**State Water Resources Control Board  
Eagle Mountain Pumped Storage Project  
(FERC Project No.13123)**

**Responses to Comments on July 2010  
Draft Environmental Impact Report (SCH #2009011010)**

**January 2013**

**Package 2 of 6**

**Figure CSLC-1: Parcel Map of Location of Project Water Pipeline (dark blue dashed line) in Relation to CSLC Parcel (#811180026) Owned by State of California.**

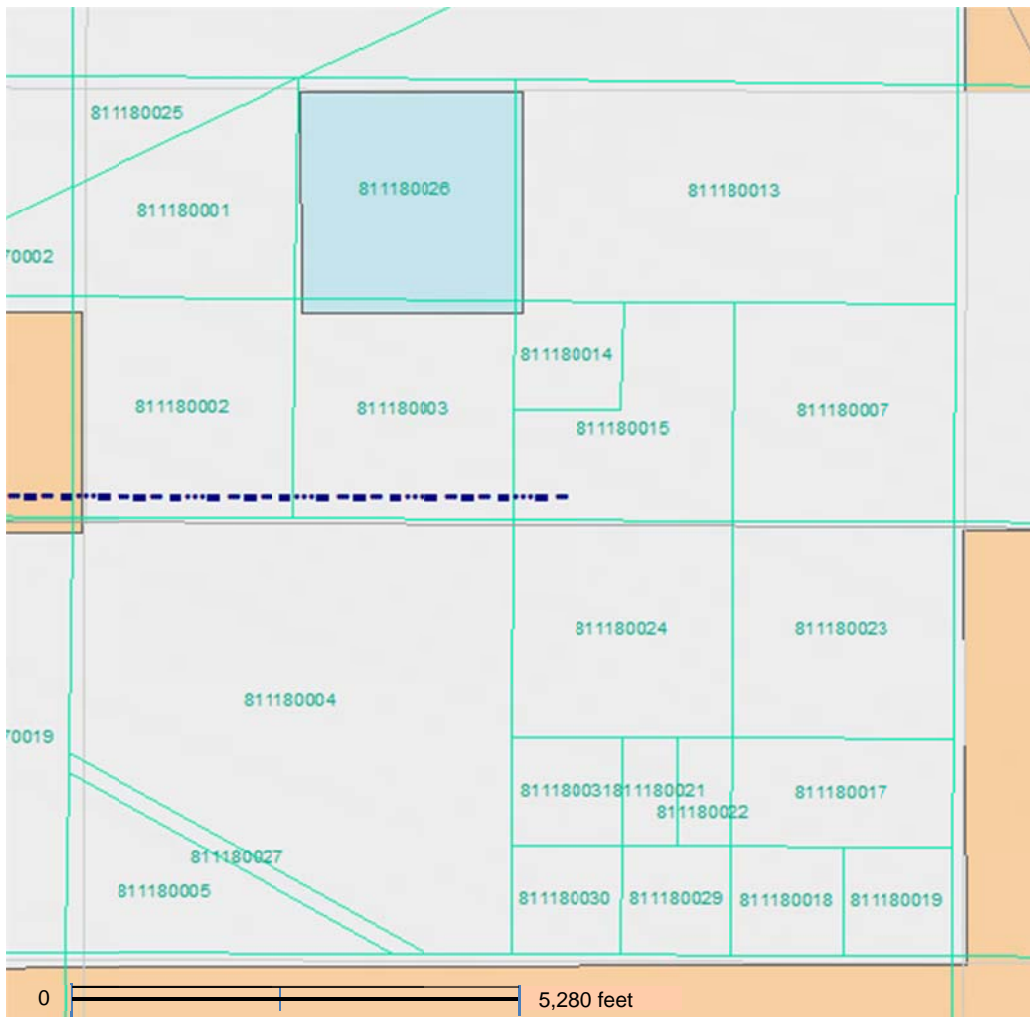
**CSLC #2:** The proposed water pipeline would likely require a right of way lease.

**Response to CSLC #2:** The following figure displays the CSLC's property (light blue parcel # 811180026), owned by the State of California, in relation to the Project's water pipeline (dark blue dashed line). The Project will not encroach on the CSLC's land at this location. The water pipeline will be approximately one-half mile from the CSLC parcel.
